In the Matter of            applications by members of the Motutangi-Waiharara  
Water Users Group for new groundwater takes from  
the Aupouri aquifer subzones: Houhora, Motutangi  
and Waiharara

Right Of Reply Evidence of

**Jon Williamson**

Dated: 4 May 2018

Figure 1. Map showing sub-divisions within the Kaimaumu Wetland.

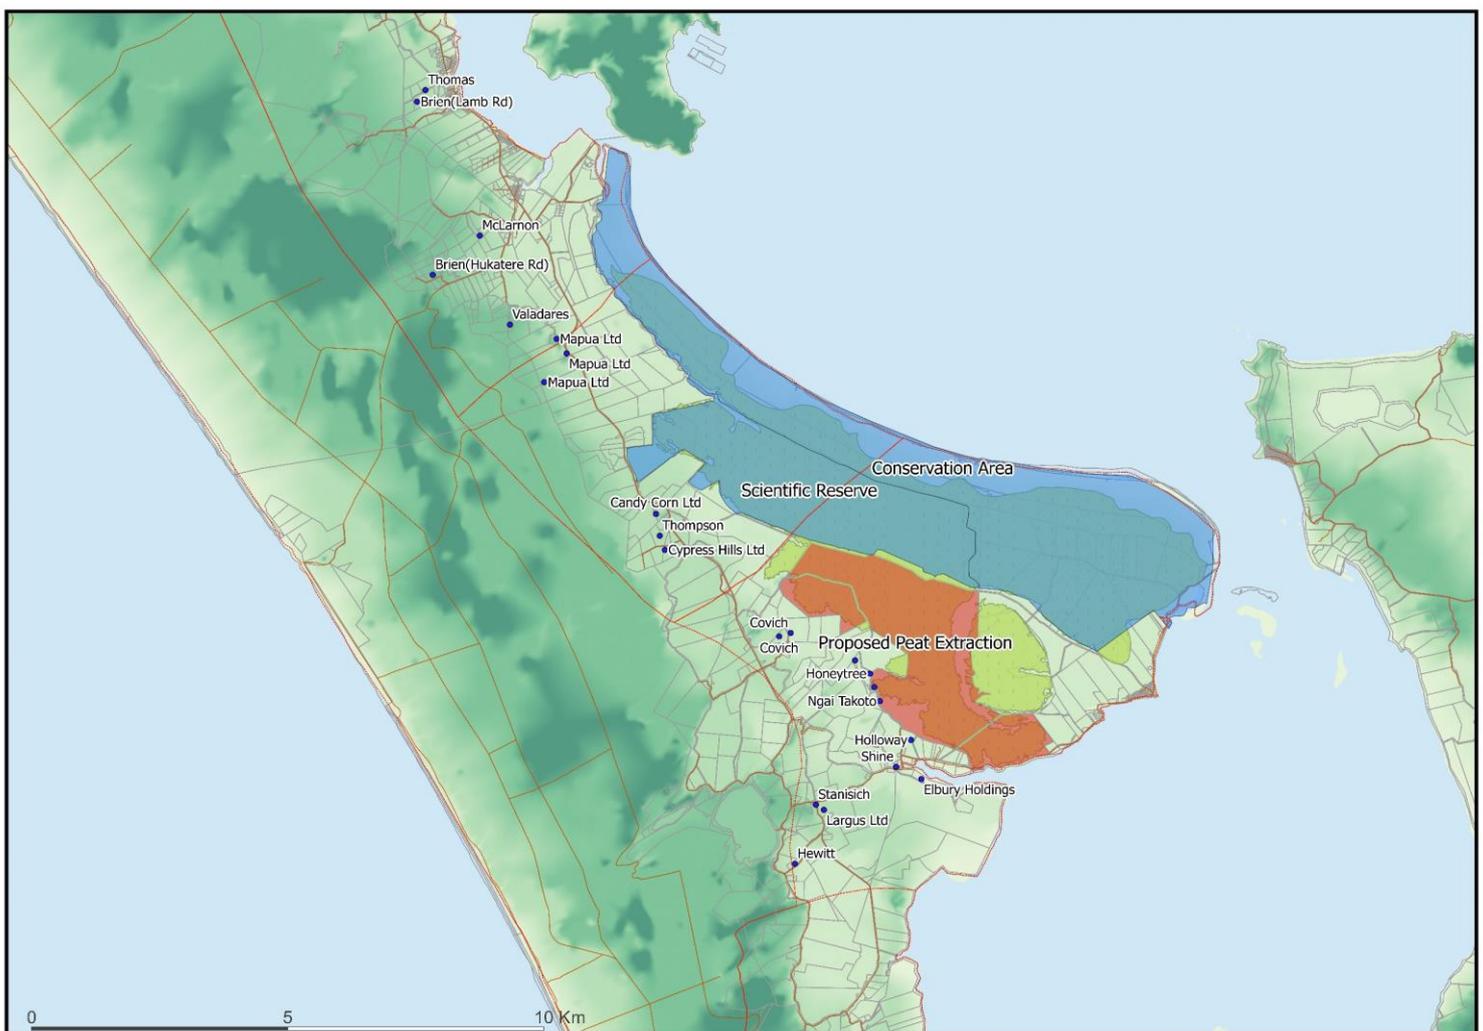
7. Ms Myers and the other experts talk extensively about the high natural values of the wetland but make no mention that not all parts of the wetland are highly valued for conservation or scientific purposes. For example, the western part of the wetland, which is adjacent to the proposed takes on Norton Road and the largest predicted drawdown (albeit  $<0.6 \text{ m}$ ), have in the past (i.e. turn of the century c.1905) been subjected to hand-dug peat extraction operations, and numerous historic drainage lines are still present within this area, as can be seen on Google Earth. Additional mining operations were operational across parts of the site

8. **Figure 3** provides a map generated in part from data provided in Ms Myers evidence, which delineates Public Conservation Land and Scientific Reserve (blue shading), from mined peat areas (red shading) that are adjacent to the takes at Norton Road.
9. In conclusion, it is important to consider any potential impacts on the wetland from the proposed abstractions in relation to the specific conservation or scientific value attached to the area, rather than generically as a whole.

Figure 2. Drawdown in the shallow aquifer assuming leaky conditions at end of worst drought in 60-year historical record (updated Figure 30 from Modelling Report).

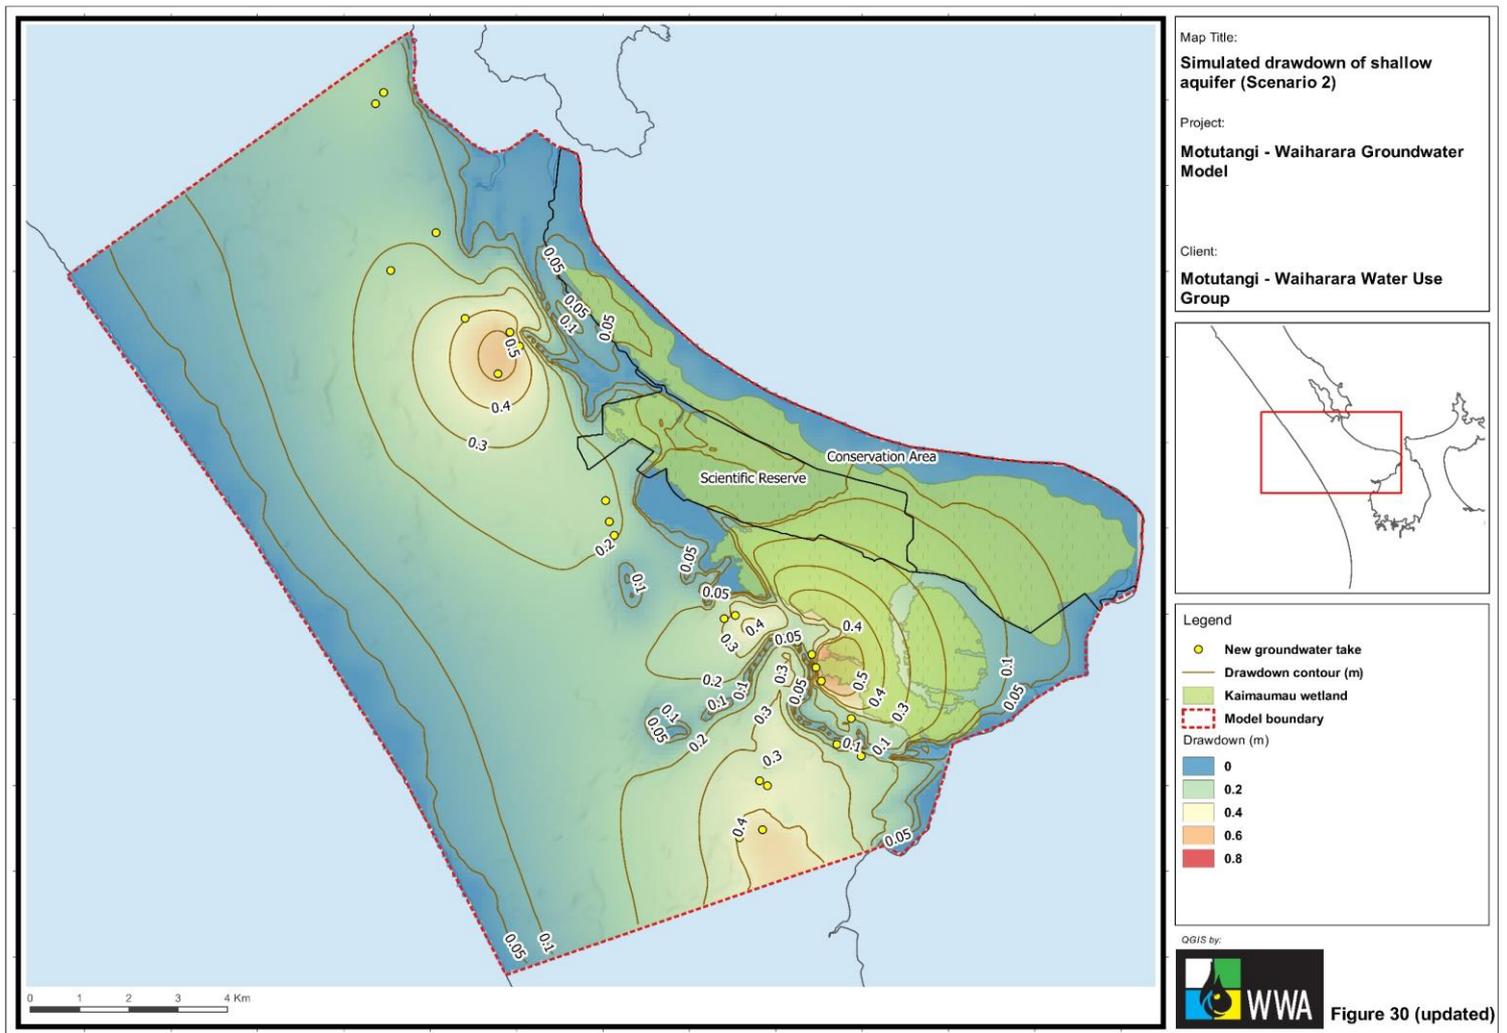
17. Mr Baker states in paragraph 36 that drawdowns of between 0.2 m and 0.6 m are relatively significant in terms of wetland systems. I do not agree with this fully as I think the comment lacks context (as discussed below), but I would agree that drawdowns greater than 0.5 m over and above seasonal oscillation can be significant for wetland plants.

18. As alluded to above, it is important to place my model predictions in context:
  - (a) the situational context is that as shown in the hydrographs in Figure 3 and 4 of Mr Blyth's evidence and the report by Hicks, et. al. (2001), the wetland plants seem to be adapted to reasonably significant (for wetland plants) seasonal oscillations, which were recorded by Mr Blyth at between 0.3-0.65 m over just the last year;

- (b) the predicted drawdown contour values were a temporal maximum reached at a single point in time at the end of the driest season in the 60-year historical climate simulation (i.e. not a permanent reduction);

- (c) the simulation for the worst-case scenario assumed that the shallow aquifer and deep aquifer were connected (i.e. a leaky aquifer scenario with no contiguous iron pan), which we know is not the case;
- (d) the predicted 0.6 m aquifer drawdown contour in the shallow aquifer was constrained to the western margin of the wetland/scrub, which is:
  - (i) outside the Scientific Reserve and Conservation Area; and
  - (ii) now understood to be subject of a recently granted peat mining consent.
- (e) the maximum predicted aquifer drawdown within Scientific Reserve and Conservation Area is actually less than 0.2 m as shown in **Figure 3**, which is an update of Figure 3a of my EIC and Figure 30 of the Modelling Report showing additional contour lines for 0.1 and 0.05 m.

Figure 3. Map showing topographic elevation model within the Kaimaumu Wetland from LINZ 8 m DEM.

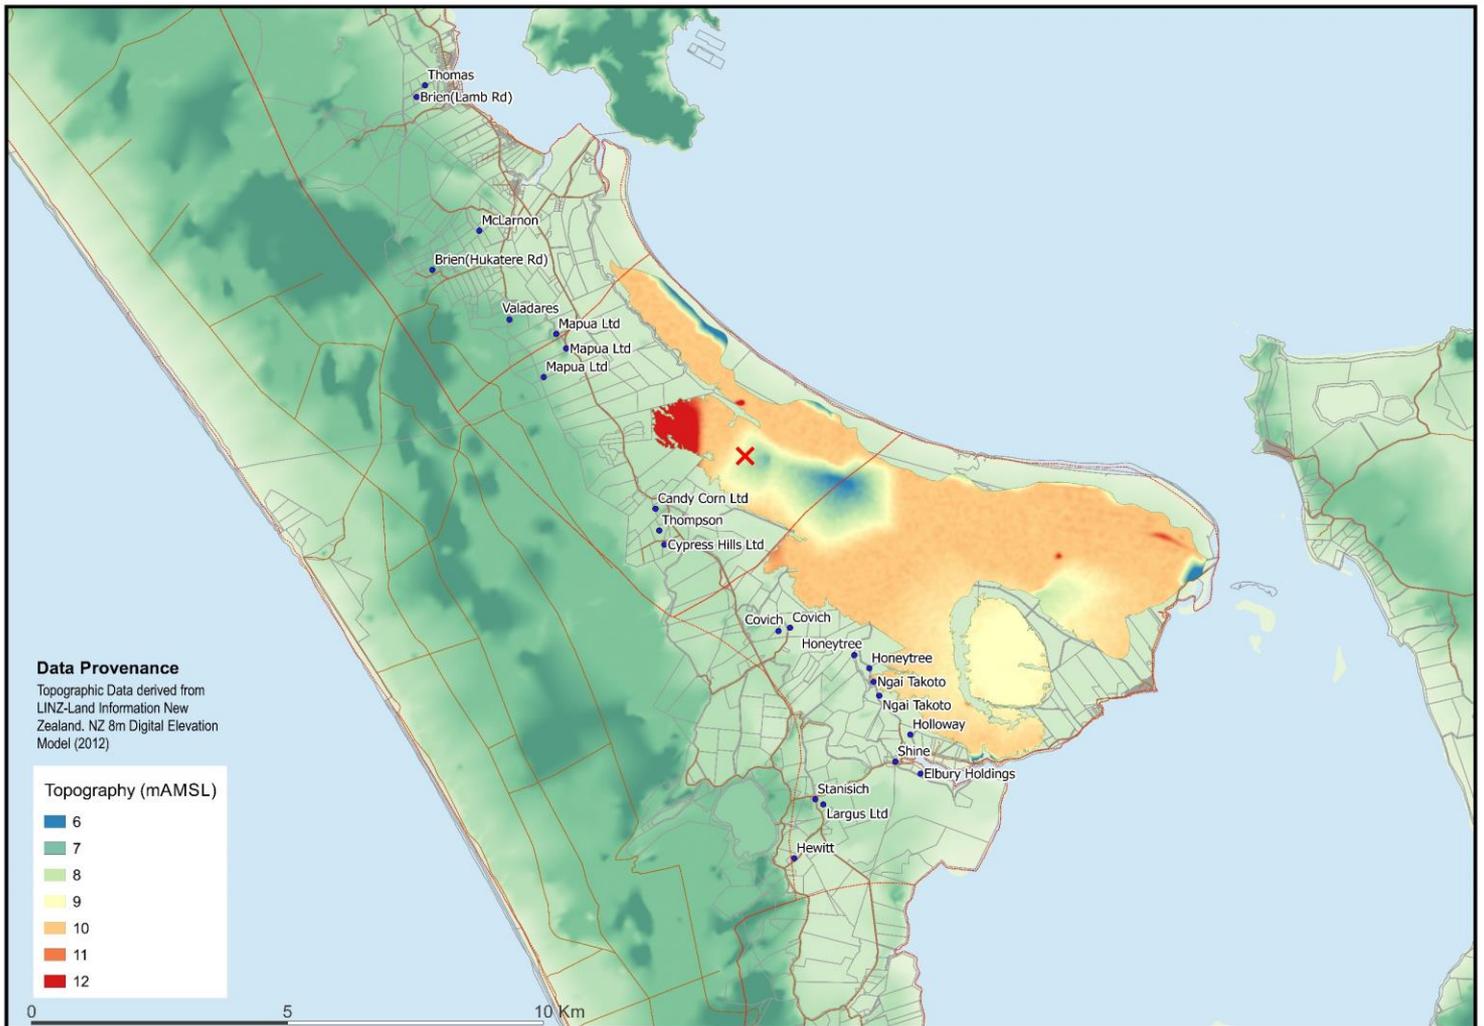
26. In paragraph 47 Mr Blyth suggests based on his “evidence presented above that it appears the wetland maybe connected to groundwater”. However, there is no evidence supporting this. There is a statement in paragraph 30 that suggests two possibilities for the standing water over the wetland, being i) storage capacity of the wetland to hold rainfall, and ii) an additional source of water (groundwater). Mr Blyth then acknowledges that the additional source of water is “yet to be characterised by scientific studies”, so paragraph 47 cannot be considered evidence of this.
27. In my opinion, the presence of standing water in this part of the wetland is purely due to the difference in topographic elevation. **Figure 3** clearly shows that topographic elevation is lower than surrounding wetland in the area of interest (marked with a cross) and further to the southeast of the area of interest.

28. Furthermore, from my MSc Thesis in the Kopouatai Peat Bog in the Waikato<sup>2</sup>, standing water over wide areas of a wetland (i.e. away from peripheral drains) is a common feature following prolonged rain due to i) high storage capacity of the peat; ii) low drainage characteristics (both horizontal and vertical), and iii) low topography.
29. Given that both the two radon samples WWA acquired from drains taking water from the wetland massif (Salles upstream and Pirini) had very low radon concentrations and significantly less than the 0.5 BqL<sup>-1</sup> trigger for groundwater impact, the standing water in the wetland is more likely due to the high storage capacity and low drainage characteristics of the peat itself, rather than groundwater inputs.
